VIRGINIA ELECTRIC AND POWER COMPANY
RICHMOND, VIRGINIA 23261

VIRGINIA ELECTRIC AND POWER COMPANY (DOMINION)
NORTH ANNA POWER STATION UNITS 1 AND 2
RESPONSE TO REQUEST FOR ADDITIONAL INFORMATION (RAI)
STATUS OF NEAR-TERM ACTION ITEMS
RESTART READINESS DETERMINATION PLAN

**Response to Request for Additional Information
Restart Readiness Determination Plan**

FIGURE 1: REVISED REQUIRED FLOOR RESPONSE SPECTRA AND TESTED SINE BEAT RESPONSE SPECTRA

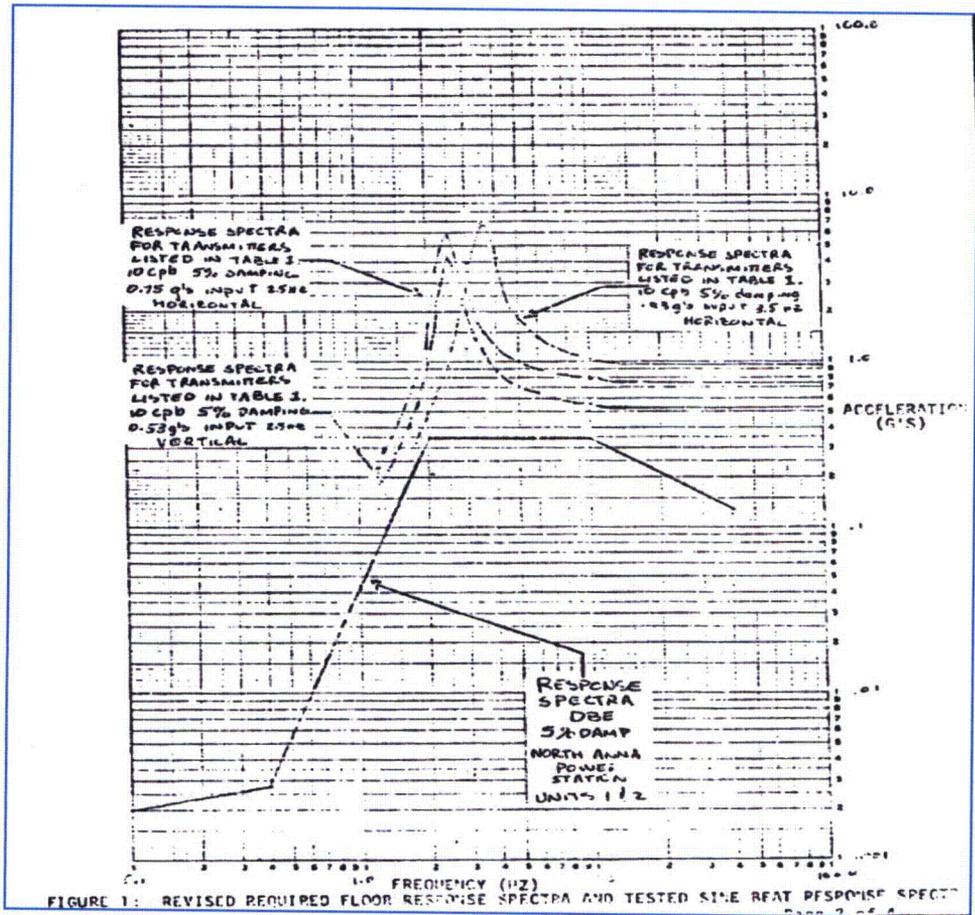
2. Foxboro Transmitter Seismic Qualification

Westinghouse Letter, VPA-80-139 "Seismic Reevaluation for Foxboro Pressure Transmitters" for North Anna Units 1 and 2 dated December 18, 1980 documents the reevaluation of the seismic qualification for the Foxboro transmitters with response spectra for the sine-beat test performed at 1.25, 1.75, 2.4, 3.5, and 5 to 35 Hz in 2 Hz increments. WCAP-7821, "Seismic Testing of Electrical and Control Equipment," and WCAP-8541, "Topical Report Seismic and Environmental Testing of Foxboro Transmitters," were referenced in the development of this document. The test results concluded that the original qualification requirements were met and therefore the transmitters are qualified under the revised seismic environment.

As mentioned above for the NIS testing, sine-beat testing results in conservative seismic levels applied to the tested equipment, as is demonstrated below.

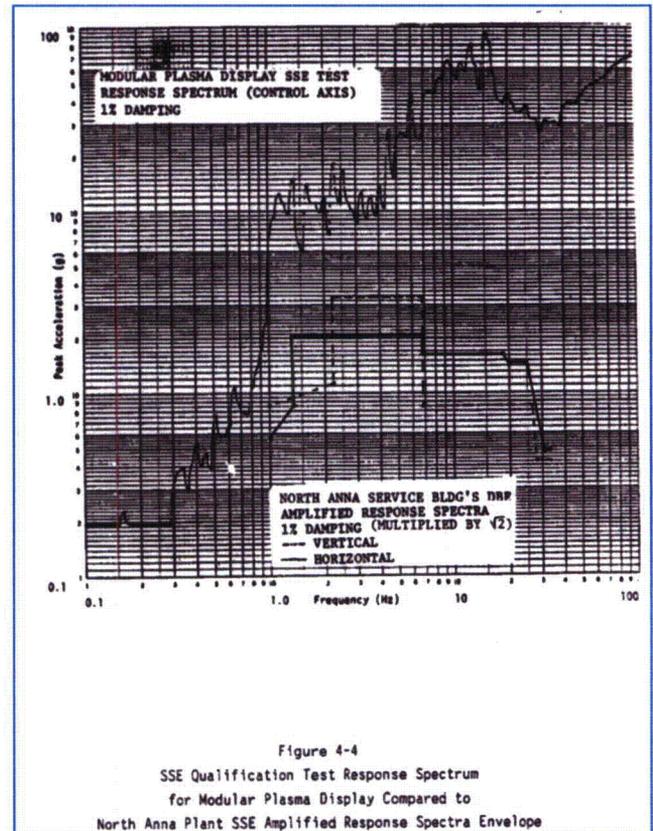
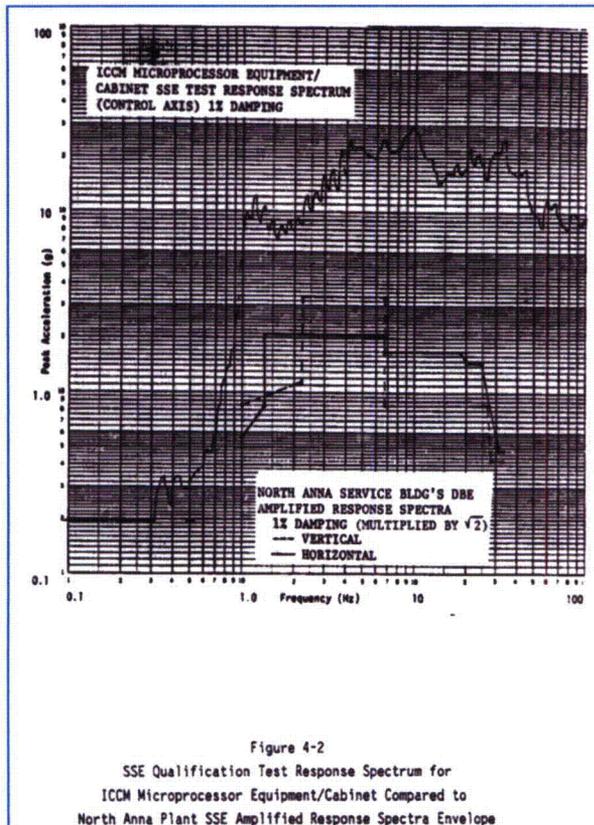
Model number 1153 Series D and Model 1154 are seismically qualified with an accuracy within $\pm 0.5\%$ of URL ($\pm 0.75\%$ URL for Range Code 0 transmitters) during and after seismic disturbance defined by a required response spectrum with a ZPA of 7g as stated in Rosemount Reports D8300040 and D8400102 and Wyle Test Report 45592-3.

Model 1154 Series H is seismically qualified with accuracy within $\pm 0.5\%$ of URL during and after seismic disturbance defined by a required response spectrum with a horizontal ZPA of 8.5g and a vertical ZPA of 5.2g as stated in Rosemount Report D870096 and Wyle Test Report 49283-1.

Based on the above ZPAs, the seismic capacities of the Model 1153, Series D and the Model 1154, Series H are also very high and will envelop any North Anna installation locations with margin.

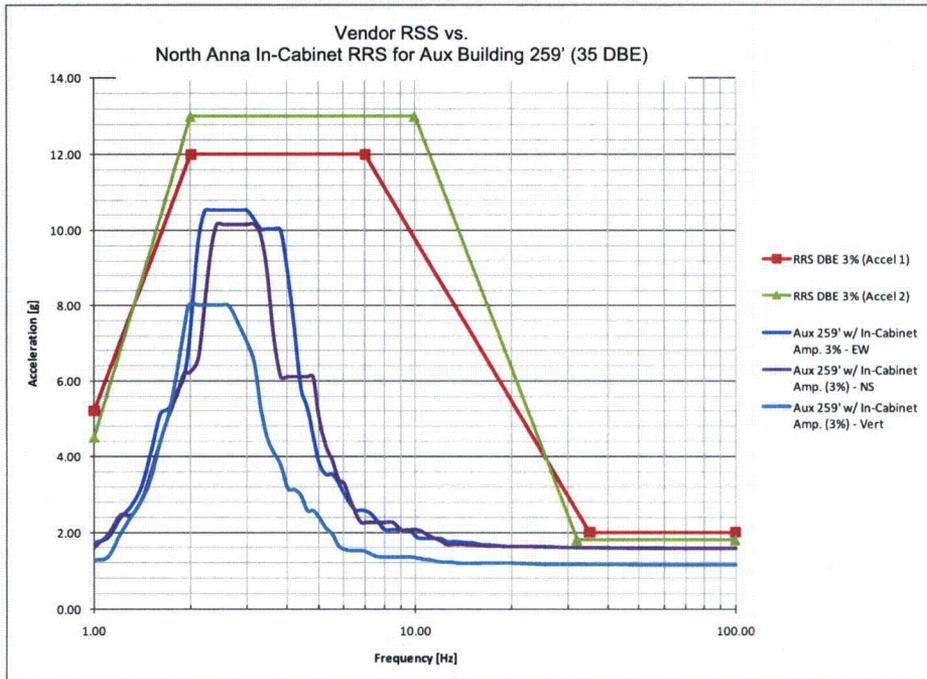
The Qualification SSE Test Response Spectrum (at 1% damping) for the ICCM Microprocessor Equipment and the Modular Plasma Display is shown below. As is demonstrated, the equipment was tested to significantly higher levels than required by Dominion's specification.

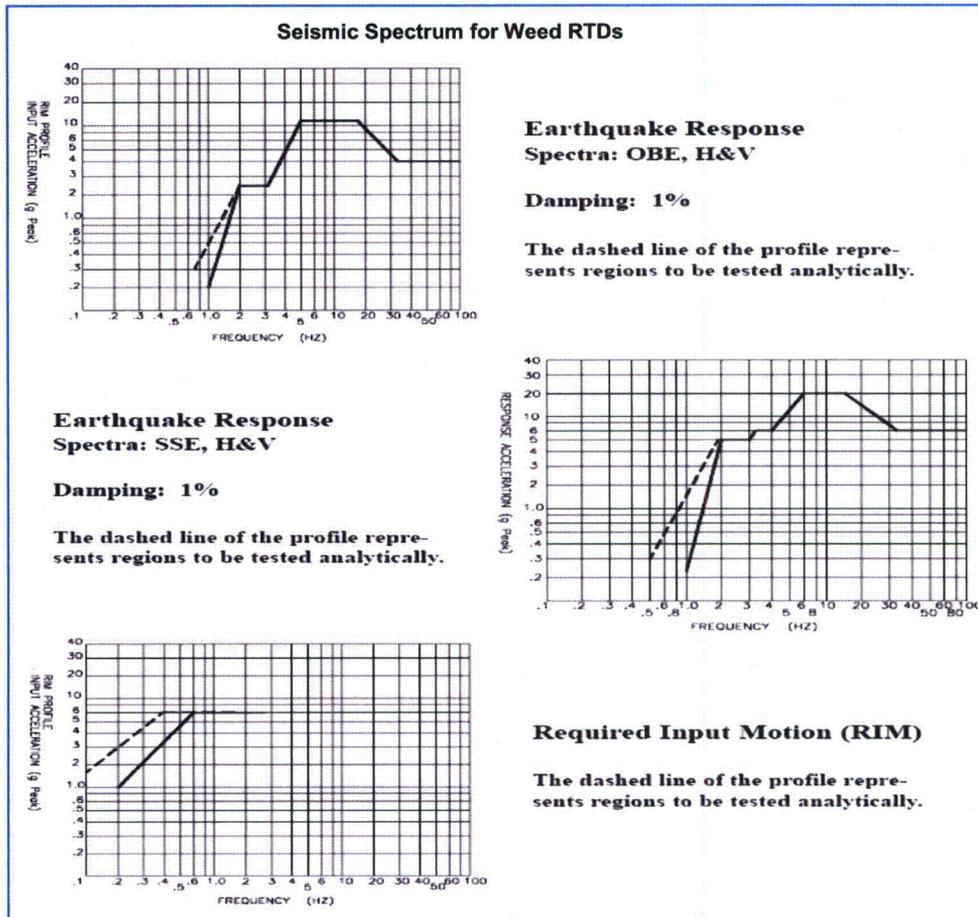
Westinghouse WCAP-7817-S2, "Seismic Testing of Electrical and Control Equipment (Low Seismic Plants)," describes the Test Procedures used for simulating the seismic test. The testing consisted of applying a sine-beat of ten cycles of the test frequency with the amplitude of the beat (acceleration of "g" level of the vibration)

increasing from a small value to the specified maximum value and returning to the initial value. Per WCAP-7817-S2, dated December 1971 the test results showed that the electrical functions of each type of equipment were maintained within the criteria defined in the report both during and after each simulated seismic condition.

As noted for the Westinghouse NIS and the Foxboro Transmitters, sine-beat testing results in a conservative levels applied to tested equipment. Spectral accelerations at 5% damping corresponding to the maximum 0.7g horizontal input applied, as shown in WCAP-7817, Figure B-2, is approximately equal to $[1/(2*0.05)](0.7) = 7g$. Therefore, there is substantial margin for applied accelerations.

Horizontal Input Acceleration from WCAP-7817

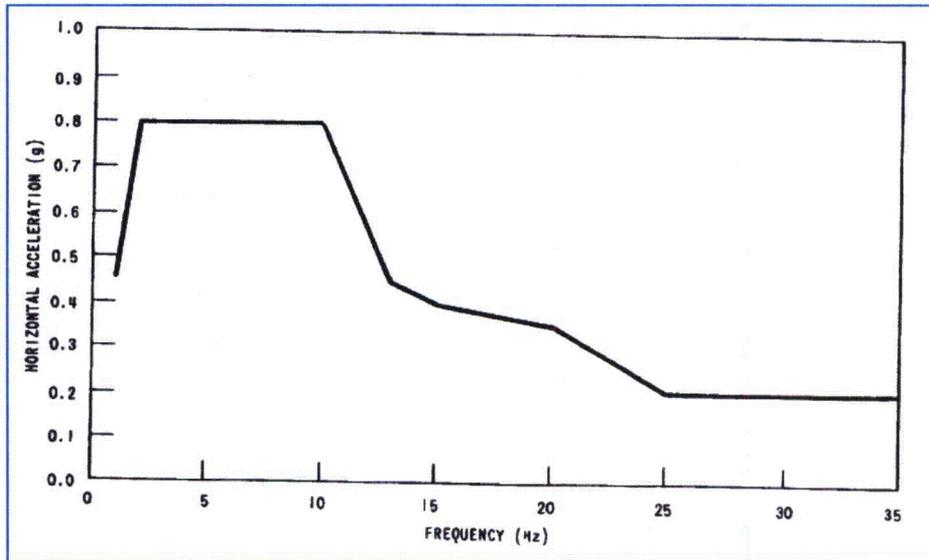
Per Seismic Qualification Test Report WCAP-7817, Supplement 4, dated November 1972, the WCID 7300 Series Process Equipment, which consists of 2-bay or 3-bay cabinet configurations, was qualified to requirements which are consistent with those of IEEE Std. 344-1971. The testing consisted of single frequency, single axis, sine-beat inputs at several discrete frequencies ranging from 1 to 35 Hz. An entire WCID 7300 series prototype cabinet was installed on the table for the test. Applied horizontal input accelerations ranged from 0.8g at low frequencies (up to 10 Hz) down to 0.2g at 35 Hz, as shown in the figure below. Vertical input accelerations were applied at 2/3 of the horizontal level.

For North Anna, the maximum Design Basis Earthquake acceleration (i.e. the ZPA in the DBE Response Spectra Curves) is 0.19g in any of the two horizontal directions, and 0.1g in the vertical direction, at the cabinet mounting location. Therefore, the test levels envelop North Anna's Design Basis levels. Although there is no specific mention of contact monitoring in the mercury-wetted relays or of the NTC, NPC, or NCH Cards in this test report, the test results indicate that no loss of signal, malfunction, or change of contact status occurred during the seismic tests. Therefore, the seismic tests qualify the 7300 Series Process Equipment to the requirements of IEEE Std. 344-1971, and envelop North Anna's seismic levels with margin. As previously mentioned in the review of the Westinghouse Nuclear Instrumentation System testing (Item 1), sine beat testing results in conservative levels applied to tested equipment. For this test, spectral accelerations at 5% damping corresponding to the maximum 0.8g horizontal input are approximately equal to $[1/(2*0.05)](0.8) = 8g$. Similarly, the peak spectral acceleration corresponding to the maximum applied vertical acceleration is approximately 5g. The minimum input acceleration of 0.2g corresponds to approximately 2g at 5% damping. Therefore, there is margin for applied accelerations over the design basis requirements.
